Δ - ADDENDUM NO. 1
October 22, 1970

PLAN AND TYPICAL SECTION

KAUMUALII AND MALUHIA ROAD INTERSECTION IMPROVEMENTS

PROJECT NO. 50D-04-70

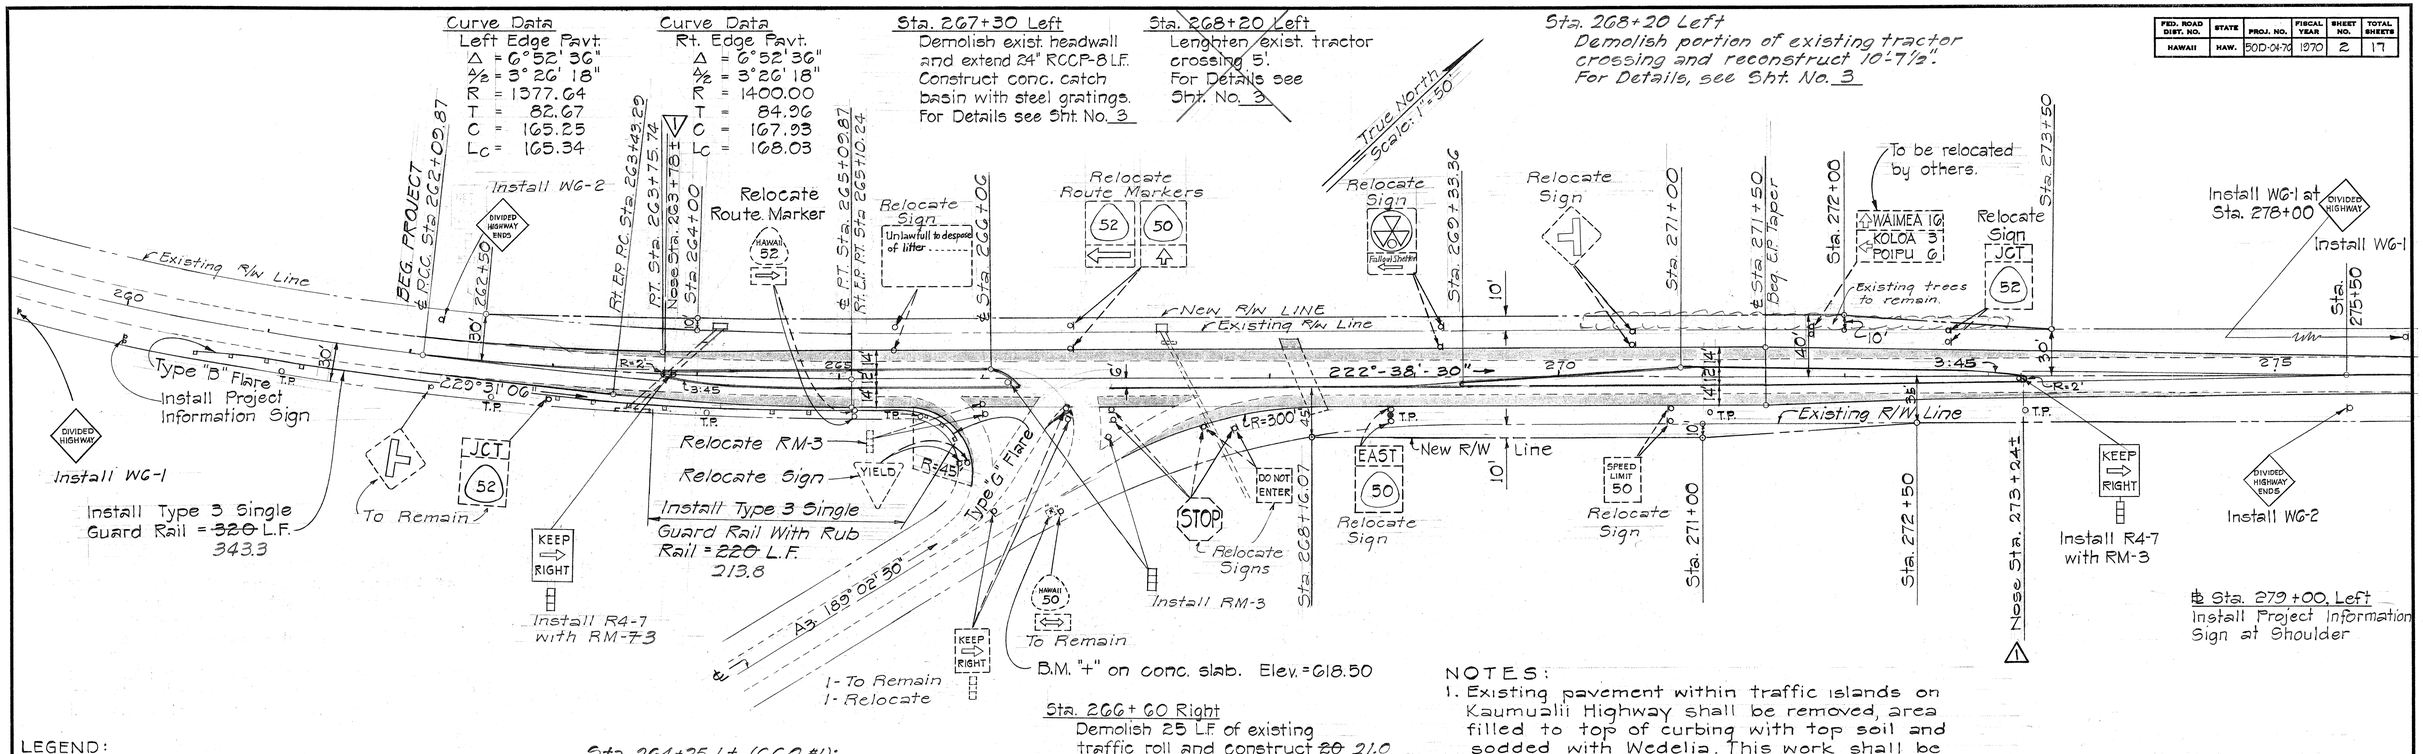
Sta. 264+25 Lt. (C.C.O. #1):

Demolish existing headwall and extend 24" RCCP-8 L.F., and construct new headwall

Sta. 266+60 Right

Demolish 25 L.F. of existing traffic roll and construct ~~20~~ 21.0 L.F. of new Type G Curb. Relocate R4-7 sign and RM3.
